# AIA<sup>®</sup> Document G716<sup>™</sup> – 2004

## Request for Information (“RFI”)

Harrison, Town-Village Recreation Center Phase 2  
270 Harrison Avenue  
Harrison, NY 10528

**RFI No.** RFI 046 - Elevator

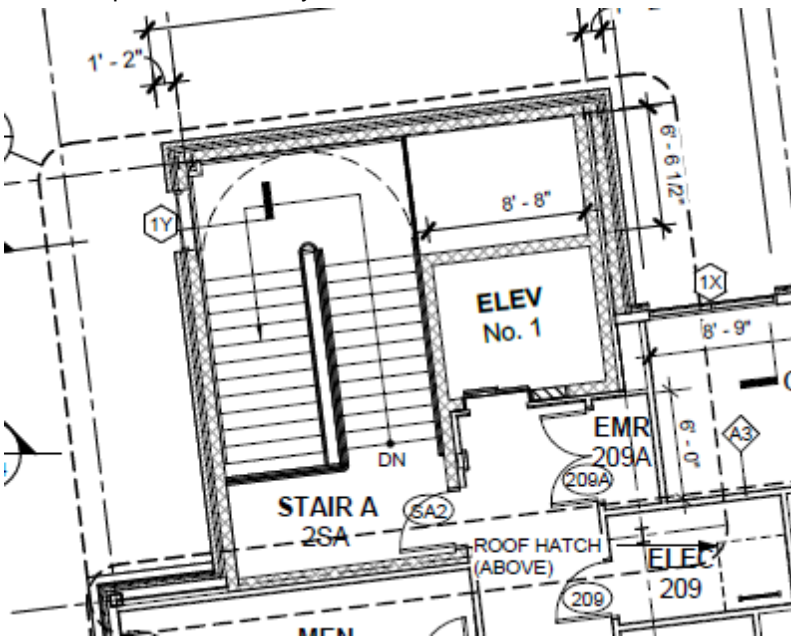
- There would need to be a clear 6' in front of the elevator entrance per code.
- The hoistway depth would need to be revised to 7'7 5/8".
- We see an EMR shown on A202 that is **not** needed for our application, so you can have that space back (regardless of the stop – see screen grab below).
- This would be a product change for us, from a Schindler 3100 to a Schindler 3300.
- We are not sure this is required to meet code and recommend reaching out to the local building department to verify.

The stop at the intermediate landing between Parking and Floor 1 has been deleted. Please proceed with the model 3100. See shop drawing review for finishes.
